**BUILDING STANDARDS COMMISSION**

RE: Ordinance #1217

Enclosed herewith is a certified copy of the City of Vernon Ordinance No. 1217.

**STEPPED FOUNDATIONS**  
**FIGURE 1809.3**  
**STEPPED FOOTING**

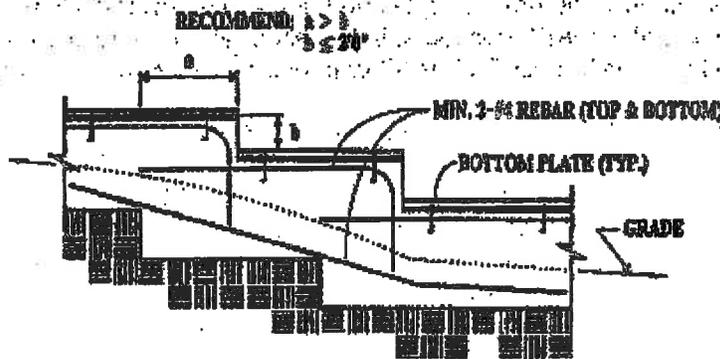
**1809.3 Stepped footings.** The top surface of footings shall be level. The bottom surface of footings shall be permitted to have a slope not exceeding one unit vertical in 10 units horizontal (10-percent slope). Footings shall be stepped where it is necessary to change the elevation of the top surface of the footing or where the surface of the ground slopes more than one unit vertical in 10 units horizontal (10-percent slope).

For structures assigned to Seismic Design Category D, E or F, the stepping requirement shall also apply to the top surface of grade beams supporting walls. Footings shall be reinforced with four No. 4 rebar. Two bars shall be placed at the top and bottom of the footings as shown in Figure 1809.3.

FIGURE 2308.9.3.2  
ALTERNATE BRACED WALL PANEL ADJACENT TO A DOOR OR WINDOW OPENING

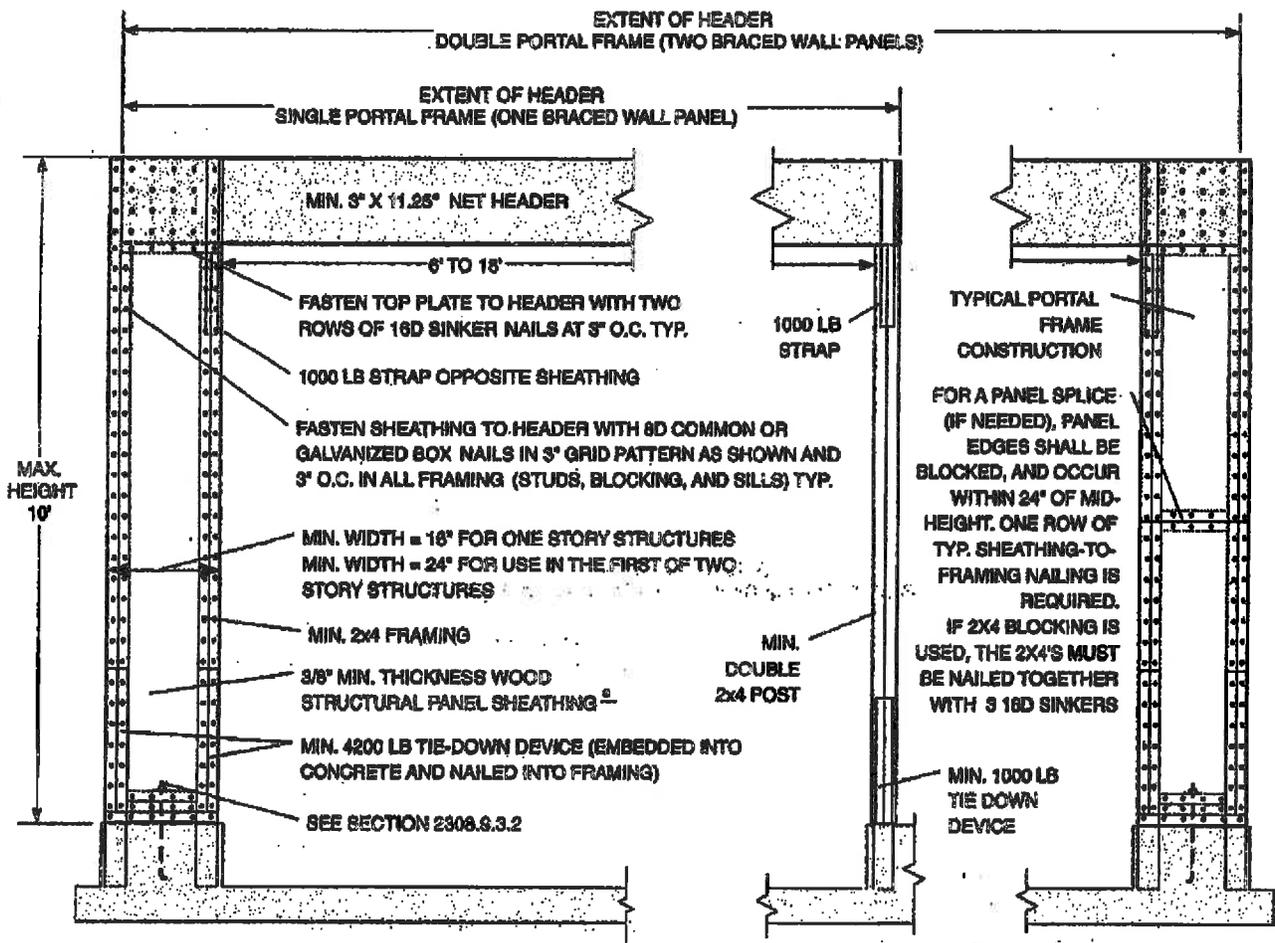
(kk) Section 2308.9.3.2 and Figure 2308.9.3.2 of the 2013 Edition of the California Building Code are hereby amended to read as follow.

**2308.9.3.2 Alternate bracing wall panel adjacent to a door or window opening.** Any bracing required by Section 2308.9.3 is permitted to be replaced by the following when used adjacent to a door or window opening with a full-length header:

1. In one-story buildings, each panel shall have a length of not less than 16 inches (406 mm) and a height of not more than 10 feet (3048 mm). Each panel shall be sheathed on one face with a single layer of 3/8-inch (9.5 mm) minimum thickness wood structural panel sheathing nailed with 8d common or galvanized box nails in accordance with Figure 2308.9.3.2. For structures assigned to Seismic Design Category D or E, each panel shall be sheathed on one face with 15/32-inch-minimum-thickness (11.9 mm) wood structural panel sheathing nailed with 8d common nails spaced 3 inches on panel edges, 3 inches at intermediate supports and in accordance with Figure 2308.9.3.2. The wood structural panel sheathing shall extend up over the solid sawn or glued-laminated header and shall be nailed in accordance with Figure 2308.9.3.2. A built-up header consisting of at least two 2 × 12s and fastened in accordance with Item 24 of Table 2304.9.1 shall be permitted to be used. A spacer, if used, shall be placed on the side of the built-up beam opposite the wood structural panel sheathing. The header shall extend between the inside faces of the first full-length outer studs of each panel. The clear span of the header between the inner studs of each panel shall be not less than 6 feet (1829 mm) and not more than 18 feet (5486 mm) in length. A strap with an uplift capacity of not less than 1,000 pounds (4,400 N) shall fasten the header to the inner studs opposite the sheathing. One anchor bolt not less than 5/8 inch (15.9 mm) diameter and installed in accordance with Section 2308.6 shall be provided in the center of each sill plate. The studs at each end of the panel shall have a tie-down device fastened to the foundation with an uplift capacity of not less than 4,200 pounds (18,480 N).

Where a panel is located on one side of the opening, the header shall extend between the inside face of the first full-length stud of the panel and the bearing studs at the other end of the opening. A strap with an uplift capacity of not less than 1,000 pounds (4400 N) shall fasten the header to the bearing studs. The bearing studs shall also have a tie-down device fastened to the foundation with an uplift capacity of not less than 1,000 pounds (4400 N).

<u>Building Code Section</u>	<u>Local Condition</u>	<u>Explanation and Findings</u>
and Figure 2308.9.3.2		<p>observed to cause massive and multiple failures of the typical 3/8" thick 3-ply plywood during the Northridge Earthquake. This proposed amendment specifies minimum sheathing thickness, nail size and spacing so as to provide a uniform standard of construction for designers and buildings to follow. This is intended to improve the performance level of buildings and structures that are subject to the higher seismic demands and reduce and limit potential damages to property. This proposed amendment reflects the recommendations by the Structural Engineers Association of Southern California (SEAOSC) and the Los Angeles City Joint Task Force that investigated the poor performance observed in 1994 Northridge Earthquake.</p> <p><u>Findings</u> - The City of Vernon is affected by the nearby location of earthquake faults that can create tremendous loss of life and structures in the city.</p>

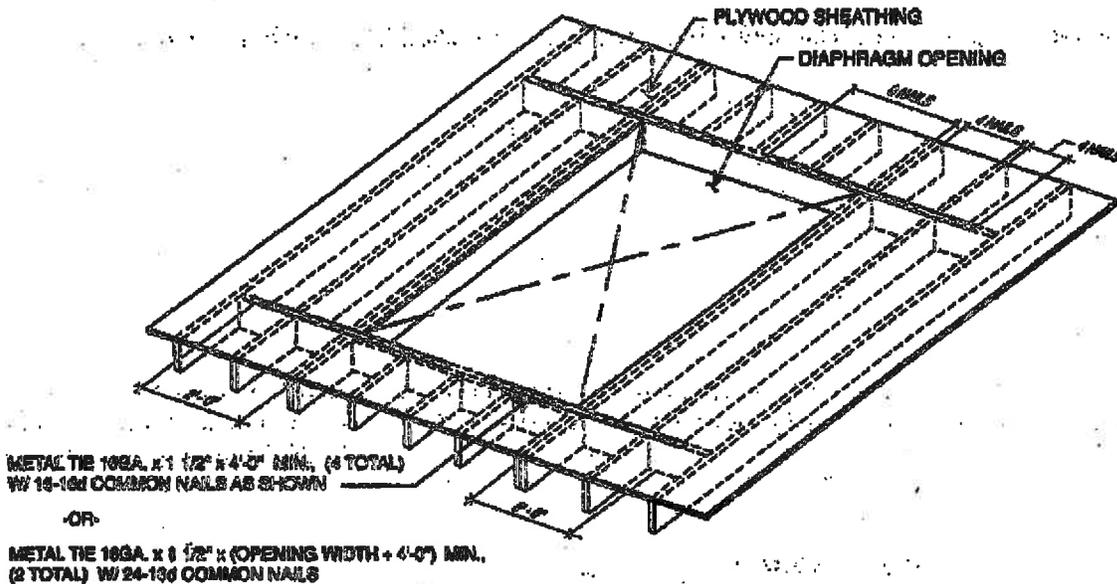
(l) Section R404.2 of the 2013 Edition of the California Residential Code is amended to read as follows:

**R404.2 Wood foundation walls.** Wood foundation walls shall be constructed in accordance with the provisions of Sections R404.2.1 through R404.2.6 and with the details shown in Figures R403.1(2) and R403.1(3). Wood foundation walls shall not be used for structures located in Seismic

R404.2	Climatic and Geological	<p><u>Rationale</u> - No substantiating data has been provided to show that wood foundation wall is effective in supporting buildings and structures during a seismic event while being subject to deterioration caused by the combined detrimental effect of constant moisture in the soil and wood-destroying organisms.</p>

**FIGURE R602.10.6.1**  
**METHOD ABW—ALTERNATE BRACED WALL PANEL**

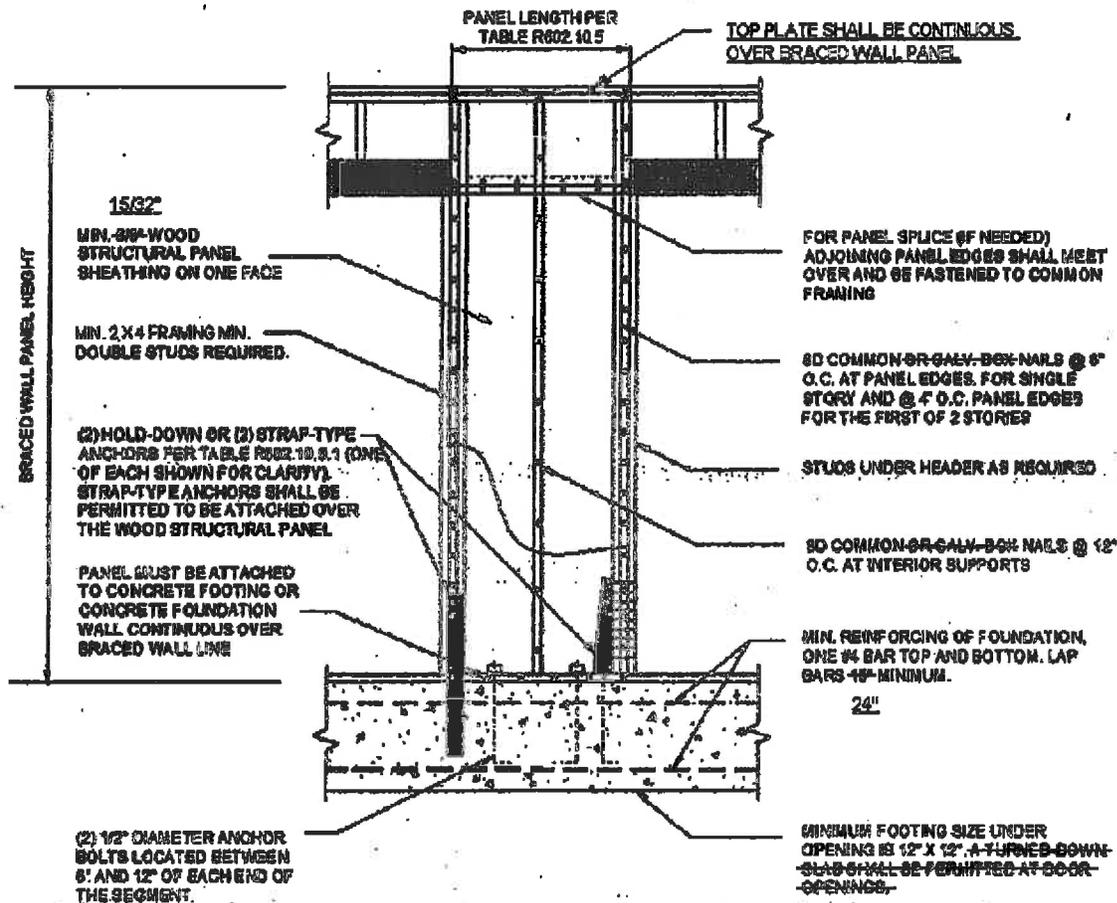
(s) Figure R602.10.6.1 of the 2013 Edition of the California Residential Code is hereby amended to read as follows:

Figure R602.10.6.1	Geological	<p><b>Rationale</b> - 3/8" thick 3 ply-plywood shear walls experienced many failures during the Northridge Earthquake. Box nails were observed to cause massive and multiple failures of the typical 3/8" thick 3-ply plywood during the Northridge Earthquake. This proposed amendment specifies minimum sheathing thickness, nail size and spacing so as to provide a uniform standard of construction for designers and buildings to follow. This is intended to improve the performance level of buildings and structures that are subject to the higher seismic demands and reduce and limit potential damages to property. This proposed amendment reflects the recommendations by the Structural Engineers Association of Southern California (SEAOSC) and the Los Angeles City Joint Task Force that investigated the poor performance observed in 1994 Northridge Earthquake. This</p>

**FIGURE R602.10.8.2**  
**METHOD PFH—PORTAL FRAME WITH HOLD-DOWNS**  
**AT DETACHED GARAGE DOOR OPENINGS**

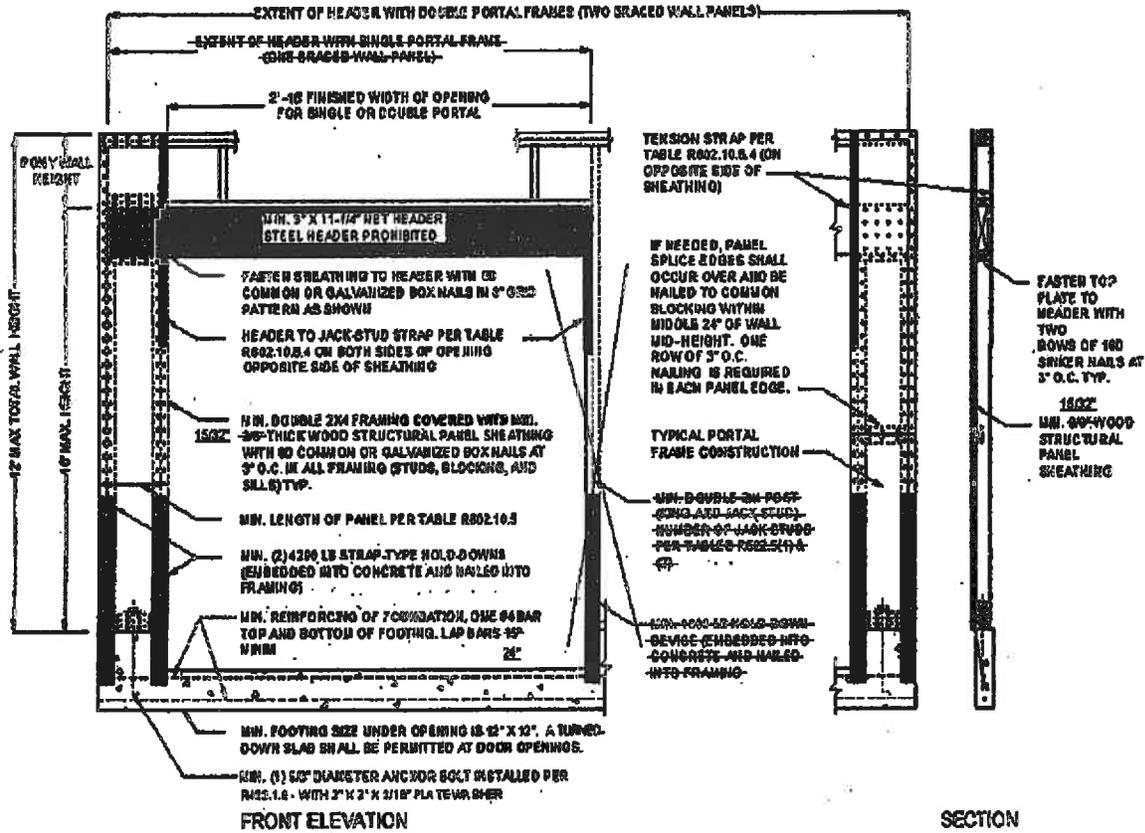
(t) Figure R602.10.6.2 of the 2013 Edition of the California Residential Code is hereby amended to read as follows:
